**RAI Volume 3, Chapter 2.2.1.2.1, Fourth Set, Numbers 25 and 26, Supplemental Question:**

**RAI Volume 3, Chapter 2.2.1.2.1, Fourth Set, Number 36, Supplemental Question:**

Figure 1.  $\Delta k_{eff}$  Values between Calculated and Measured Isotopic Compositions

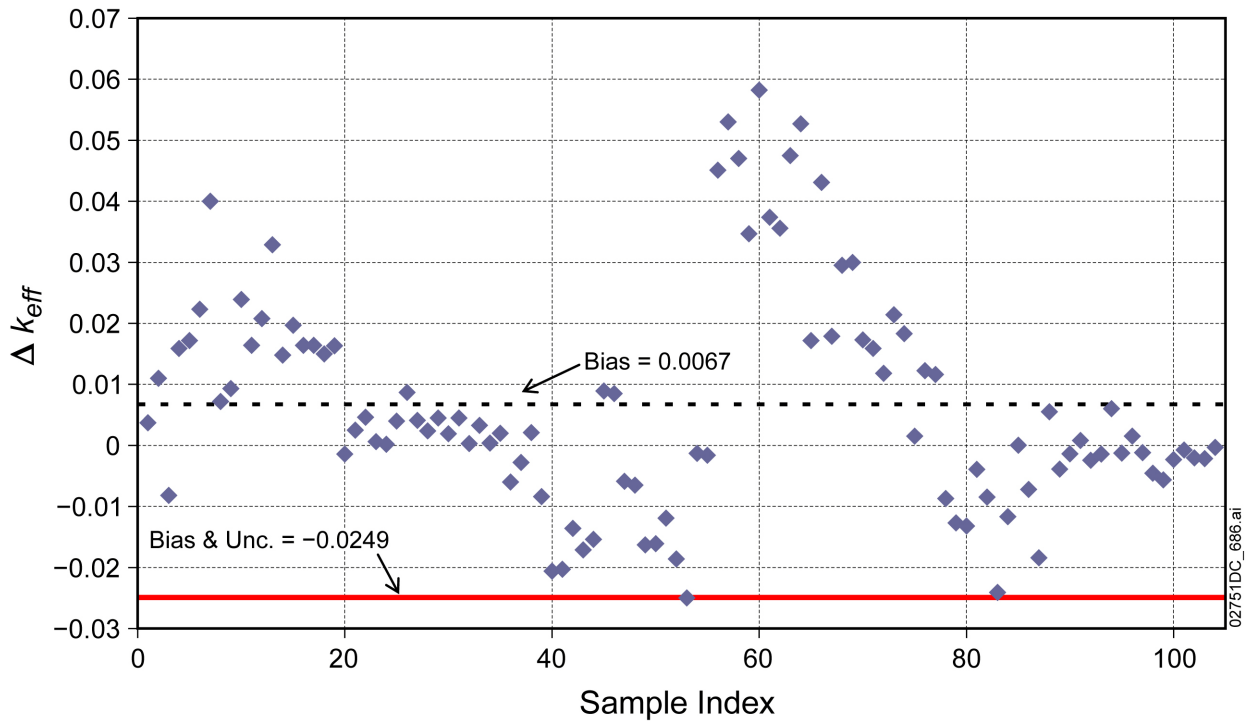
Where in the responses to RAIs 3.2.2.1.2.1-4-025 and 3.2.2.1.2.1-4-026 did DOE justify crediting the five metal isotopes ( $^{95}\text{Mo}$ ,  $^{99}\text{Tc}$ ,  $^{101}\text{Ru}$ ,  $^{103}\text{Rh}$ , and  $^{109}\text{Ag}$ )? Only 11 radiochemical analysis (RCA) samples, all from TMI-1 RCA data, were supplied for most of these metals. The measurement methods used for these samples involved relatively low-precision techniques resulting in large experimental uncertainties. No justification was provided to support the small sample size as bounding the inventory of pressurized water reactor (PWR) spent nuclear fuel (SNF) assemblies and the associated uncertainties in the data.

Given the lack of data, provide additional information on how the uncertainties associated with measuring and predicting the isotopic composition as well as the uncertainties in the available RCA samples are accounted for when representing the bounding isotopic composition for the various PWR assembly fuel types and operating histories.

Each of the radiochemical analysis (RCA) data sets has a different total number of nuclides that were measured, but collectively these data sets include measurements for all of the principal isotopes identified in SAR Table 2.2-9, including the five metal isotopes listed in the RAI. These data sets were evaluated using the “direct-difference” method (Gauld 2003, Section 3.2.3) to quantify the net bias and uncertainty in the  $k_{eff}$  calculation due to the variability in the predicted nuclide concentrations. All publicly available at the time of LA submittal RCA data were included in the evaluations. In order for the direct-difference method to be used, the data population needs to include measurements for all radionuclides selected for burnup credit analyses. The Three Mile Island (TMI) data set contains measurements for the five metal fission products cited in the RAI. When using the direct-difference approach, individual isotopic measurement uncertainty is not evaluated directly but is reflected across the sample population and captured in the  $k_{eff}$  results. The TMI data have larger experimental uncertainties, which are noticeable in the  $\Delta k_{eff}$  calculations, and therefore result in a larger overall variance within the  $\Delta k_{eff}$  sample population. By using the direct-difference approach, the individual laboratory systematic errors are captured along with the individual nuclide uncertainties, and the aggregate effect is calculated as a  $\Delta k_{eff}$  value. By evaluating the RCA data collectively with the direct-difference approach, the net bias and uncertainty on  $k_{eff}$  ( $\Delta k_{ISO}$ ) is determined for the system of interest. The mean bias within the total sample set is 0.0067 but due to the large variance within the sample set and the fact that the data are not normally distributed, the distribution-free tolerance limit method is used to calculate the lower-bound tolerance limit, which incorporates a very large uncertainty penalty (as compared to a normally distributed sample population), resulting in a net bias and uncertainty ( $\Delta k_{ISO}$ ) of  $-0.0249$  (Figure 1). This large  $\Delta k_{eff}$  penalty is primarily due to the spread (uncertainty) in the data as well as the low sample count, and is applied directly in the calculation of the critical limit.

The collective uncertainty penalty factor associated with the  $\Delta k_{eff}$  distribution (0.0067 – (–0.0249) = 0.0316) is much larger than the effects on  $k_{eff}$  of the uncertainty associated with the measurements of the individual nuclides for the metal fission products. Example reactivity sensitivity factors provided in *Evaluation of Cross-Section Sensitivities in Computing Burnup Credit Fission Product Concentrations* (Gauld and Mueller 2005, Table 16) demonstrate that the differential change in system  $k_{eff}$  due to a change in the macroscopic cross sections (which is reflective of changes in the isotopic number density),  $\frac{\delta k / k}{\delta n / n}$ , ( $^{103}\text{Rh}$ ,  $8.24 \times 10^{-3}$ ;  $^{99}\text{Tc}$ ,  $2.8 \times 10^{-3}$ ;  $^{95}\text{Mo}$ ,  $1.46 \times 10^{-3}$ ;  $^{109}\text{Ag}$ ,  $1.11 \times 10^{-3}$ ;  $^{101}\text{Ru}$ ,  $8.95 \times 10^{-4}$ ) is bounded by the collective  $\Delta k_{eff}$  uncertainty (i.e.,  $3.16 \times 10^{-2}$ ). The large  $\Delta k_{ISO}$  penalty factor, which is used in conjunction with conservative assumptions relative to fuel types and operating histories, provides reasonable assurance that uncertainties in isotopic predictions are bounded in the loading curve analysis. As additional data become available and can be included in the sample population, the data uncertainty is expected to decrease, resulting in a smaller isotopic bias and uncertainty ( $\Delta k_{ISO}$ ) and greater margins in the current analysis results.

Figure 1. BWR Loading Curve

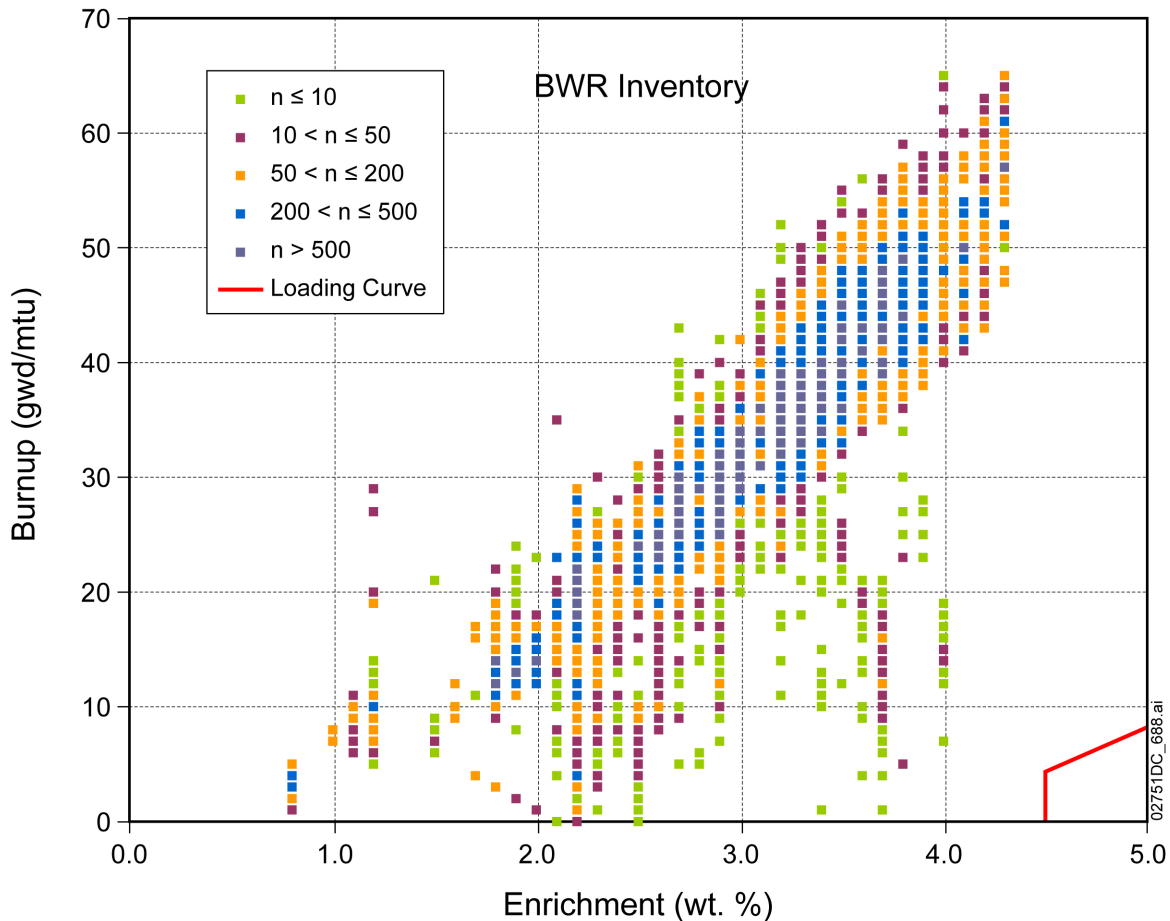
Where in the response to RAI 3.2.2.1.2.1-4-036 did DOE account for uncertainties in modeling isotopic compositions for boiling water reactor (BWR) spent nuclear fuel (SNF)?

Given the lack of BWR radiochemical assay (RCA) samples and the greater complexities of BWR SNF characteristics, justify that the analytical methods and supporting data used to generate the BWR loading curve adequately bound the BWR SNF inventory.

3. Fresh fuel evaluations were performed in *44-BWR Waste Package Loading Curve Evaluation* (BSC 2004, Table 23) and demonstrated that the  $7 \times 7$  is a more reactive assembly design in a waste package configuration than the  $8 \times 8$  and  $9 \times 9$  designs.
4. BWR fuel assemblies with initial enrichments for which burnup credit is taken (assemblies that are over 4.5 wt% enriched), will have substantial margin between what would be needed to meet the loading curve requirements and the projected assembly discharge burnups (Figure 1 shows assemblies above 4.0 wt% enrichment are in excess of 40 GWd/MTU burnup representing a margin of at least 30 GWd/MTU for assemblies requiring burnup credit).

Because 4.5 wt%  $^{235}\text{U}$  is the maximum enrichment that can be loaded into disposal canisters as fresh fuel, some BWR burnup credit is necessary to accommodate fuel assemblies with higher initial enrichments (i.e.,  $> 4.5$  wt%  $^{235}\text{U}$ ) than the projected waste stream inventory illustrated in Figure 1. As can be seen in Figure 1, only a very small amount of burnup credit,  $\sim 8$  GWd/MTU (less than what is obtained in a typical irradiation cycle), is required for disposal of BWR fuel assemblies up to 5.0 wt%  $^{235}\text{U}$  initial enrichment. Note at this low burnup and below, modern BWR assemblies have  $\text{Gd}_2\text{O}_3$  remaining in the fuel, which reduces their reactivity. The BWR design basis assembly used in the generation of the BWR loading curve is a GE-2a  $7 \times 7$  assembly with no burnable absorbers, no water rods, and depleted under extreme conditions to harden the neutron spectrum and breed in excess plutonium as discussed in *Isotopic Generation and Confirmation of the BWR Application Model* (Wimmer 2004; Massie 2004). This assembly design is representative of a “simple” BWR assembly design as compared to the newer and more advanced fuel designs that incorporate the use of integral burnable absorbers, part-length rods, water holes, higher initial enrichments as well as axially varying enrichments, and other features (all designed to increase overall fuel residency time, i.e., extend burnup). The design improvements of the more advanced designs ultimately result in a net decrease in the total fissile mass available in the fuel assembly at discharge (i.e., fuel is replaced with burnable absorber, and removed from part-length rods and water holes).
